# Product Change Notification

<b>Date Issued :</b>	December 12, 2025	<b>PCN Number :</b>	517543
<b>Reason for Change :</b>	Change Supplier		
<b>Description of Change :</b>	This notification is to inform you that a supplier to Molex Lincoln Nebraska is adding an additional raw material sub-supplier impacting the products referenced in the attached list. There will be no changes to any fit, form, function, or appearance of product based on the addition of the sub-supplier. Supplier to Molex Lincoln Nebraska will not change.		
<b>Assessment of Change :</b>	First Article Inspection Supplier Qualification Test Report/s		
<b>Planned Implementation Date :</b>	October 09, 2026		
<b>Customer Sample Availability Date:</b>	June 30, 2026		
<b>Last date to request Samples by Customer :</b>	March 31, 2026		
Please note if Samples are not requested as per Customer Samples Request date, it may take additional 4-6 weeks to arrange Samples.

2156740051 Revision A

Before Picture

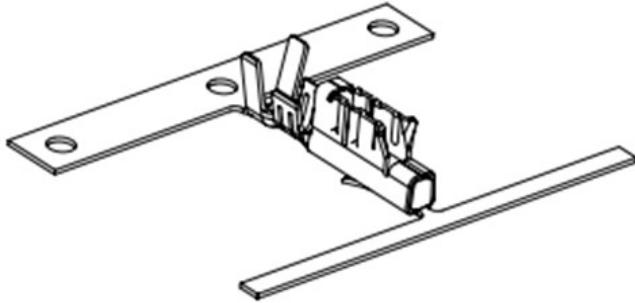
## Metal Material Supplier to Molex to add additional raw material supplier

- To ensure continuous product quality and delivery, a supplier to Molex Lincoln, Nebraska is adding an additional raw material supplier source.
  - Molex Lincoln Nebraska will still receive material from current supplier.
  - The material will be the same as current supplied material
  - Production process at supplier will be unchanged
- Product Impact
  - NO change to any Form, Fit, Function or Appearance of product
- Part Numbers Impacted
  - See attached List
- Qualification Reports
  - Qualification reports will be available upon request after June 30, 2026
    - Please note if Qualification Reports are not requested by March 31, 2026, it may take an additional 4-6 weeks to arrange for Qualification data to be available.
- **PCN will be implemented once all required qualifications/validations have been completed.**
